Service Bulletin

14-030

Recall: Front Passenger's Airbag Inflator May Produce Excessive Pressure After Long-Term Exposure To High Absolute Humidity

Supersedes 14-030, dated December 11, 2014, to revise the information highlighted in yellow

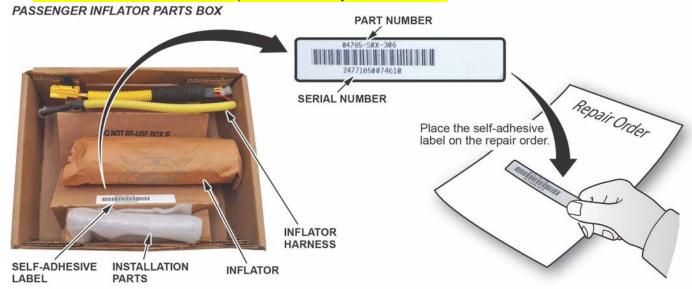
A label that has the part number and serial number of the inflator may be included in each airbag inflator kit to make tracking this information easier.

- 1. Peel the label located inside the inflator box from its backing and attach it to the R.O. For the warranty claim to be paid, the **replacement inflator part number that you received** must be on the warranty claim and your warranty clerk must enter the serial number in the Diagnostic Trouble Codes field.

- The replacement part number is printed on the top part of the label and the serial number is printed on the bottom. Make sure you attach the label to the R.O. and give it to the warranty clerk.
- There may also be a colored sticker located in the kit, ignore it because it is not used.
- Not all inflator kits have a label included. In those cases, write the serial number and part number from the side
 of the inflator box on the R.O. The part number always starts with 047.
